MT ZION BAPTIST CHURCH SUBDIVISION

APPLICATION NUMBER 2 DATE November 16, 2006
APPLICANT Mt Zion Baptist Church Subdivision
REQUEST Subdivision

MT ZION BAPTIST CHURCH SUBDIVISION

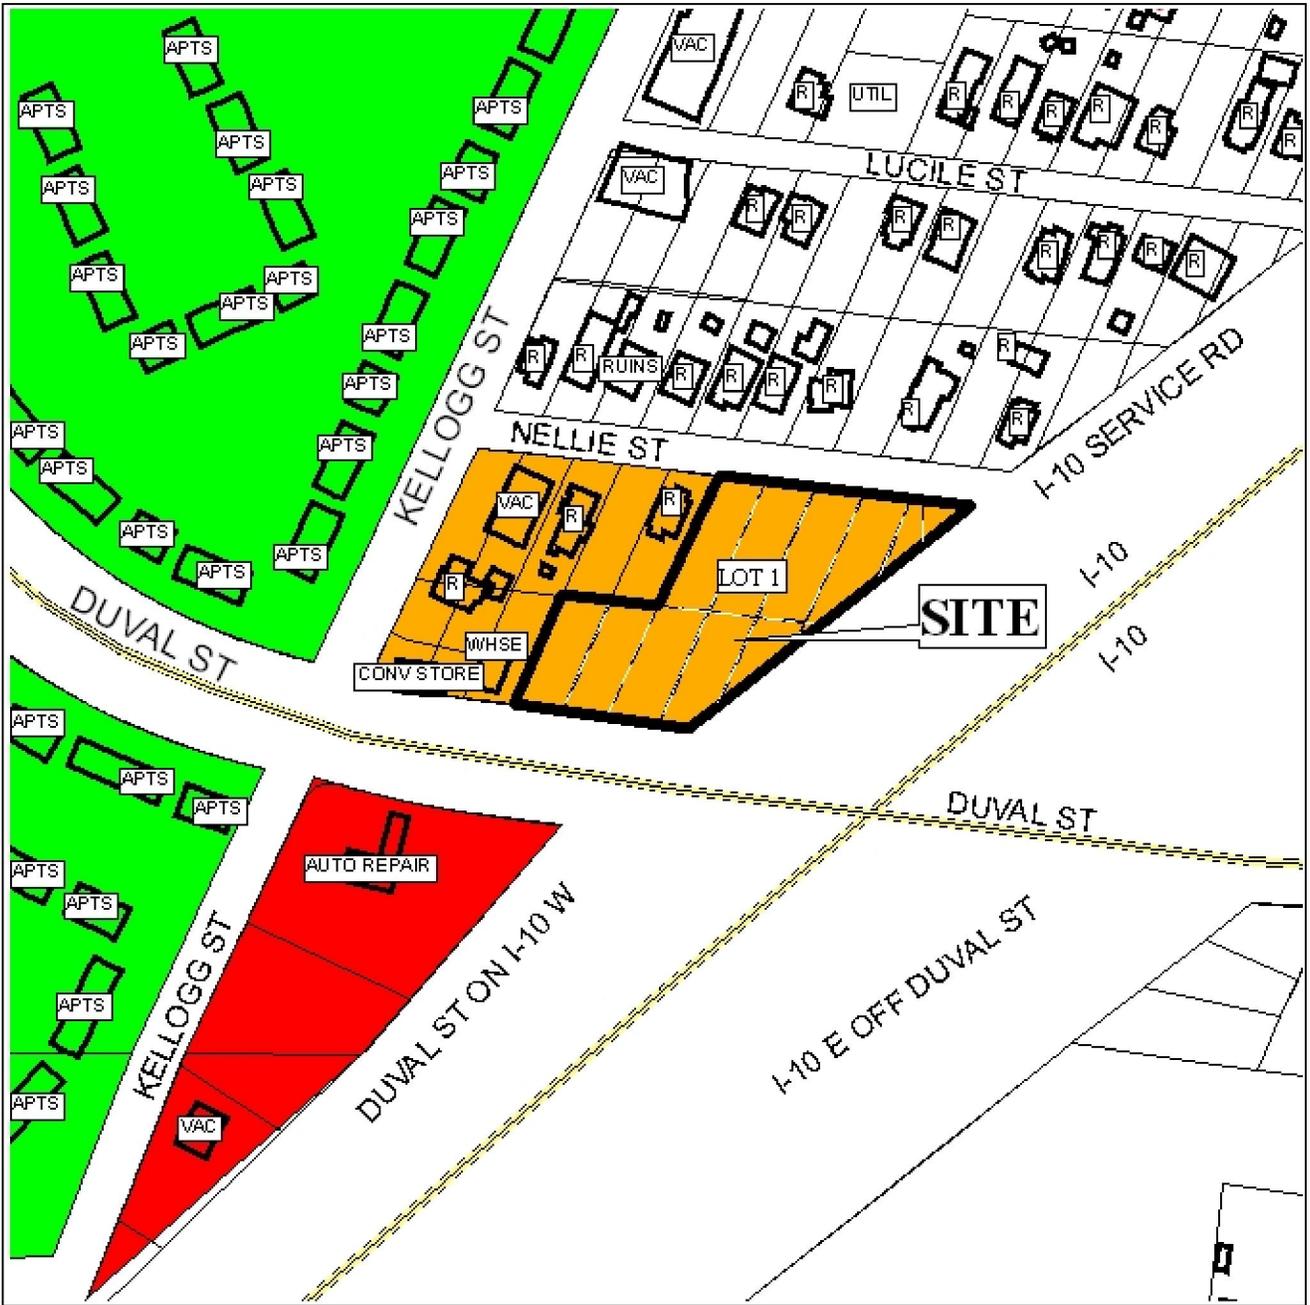
The site has property lines at two intersection corners. Section V.D.6. of the Subdivision Regulations requires that "*property lines at street intersection corners shall be arcs having radii of at least 10 feet or shall be chords of such arcs.*" The plat should be revised to reflect this requirement at all intersection corners.

The 25-foot minimum building setback line, required in Section V.D.9., is not shown for the subdivision, but would be required on the Final Plat, if approved. The setback line should be depicted from all street frontages.

Finally, it appears that Duval Street is misspelled on the plat.

Based on the preceding, the plat is recommended for Tentative Approval, subject to the following conditions: 1) dedication of sufficient right-of-way to provide 25 feet as measured from the centerline of Nellie Street; 2) placement of a note on the plat stating that the site is denied access to Nellie Street, and limited to one curb-cut onto Duval Street and one curb-cut onto the Interstate 10 service road, with the size, design and location to be approved by Traffic Engineering and ALDOT, and comply with AASHTO standards; 3) revision of the property line at all street intersections to reflect the radius requirements stated in Section V.D.6. of the Subdivision Regulations; 4) depiction of the 25-foot minimum building setback line from all street frontages, including dedications and adjustments for intersection corners; 5) labeling of the lot with its size in square feet, or provision of a table on the plat with the same information; 6) correction of the spelling of Duval Street; and 7) full compliance with all other municipal codes and ordinances.
